1632 COIN CELL SM RETAINER

2896

5.13.19 CHANGE AS PER ECN 19-051

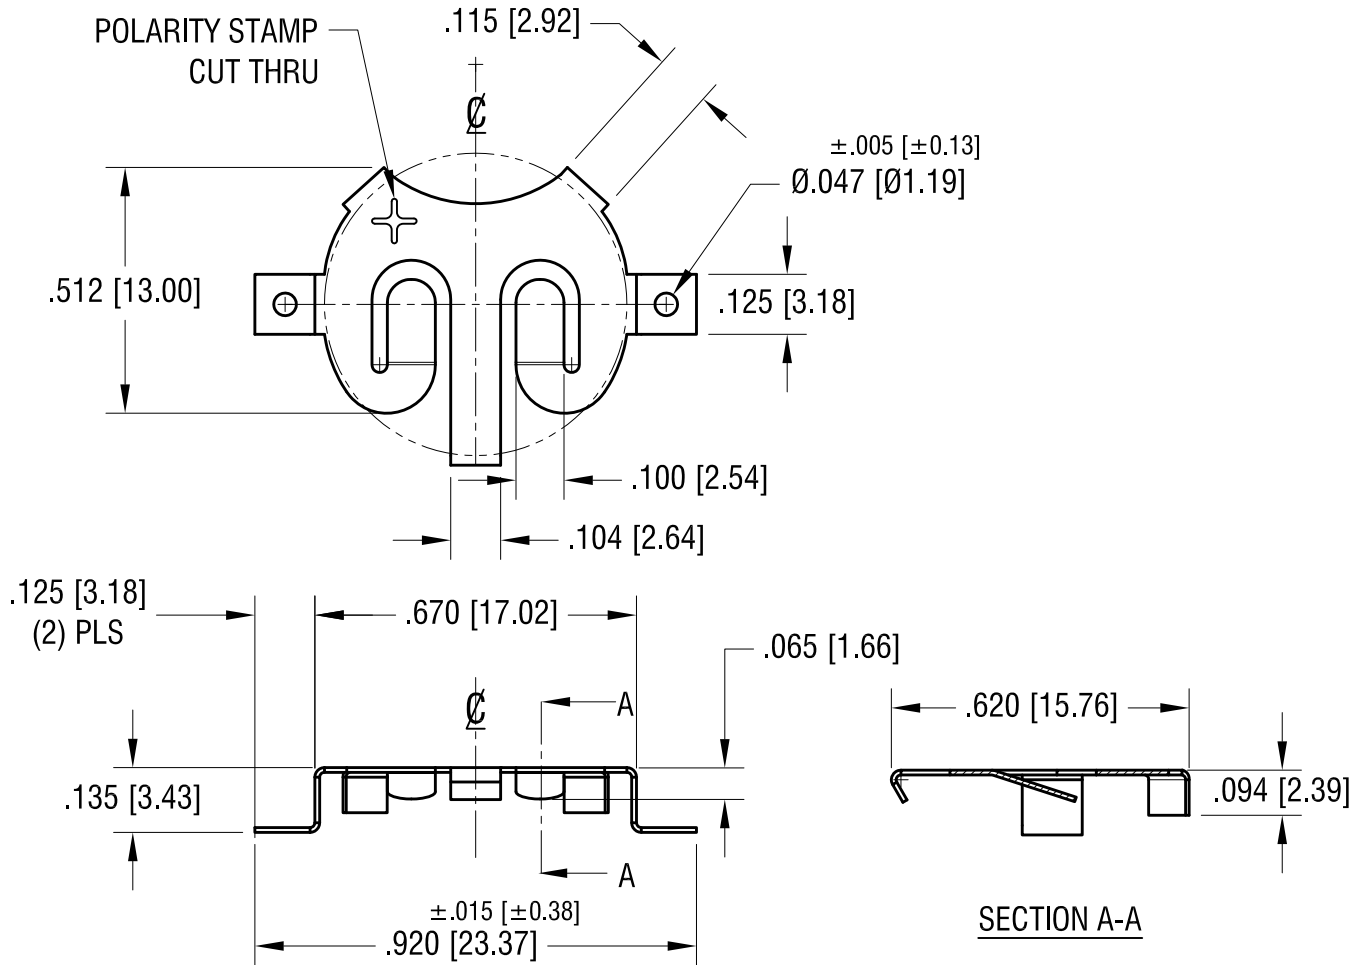
REMOVE DIMPLES
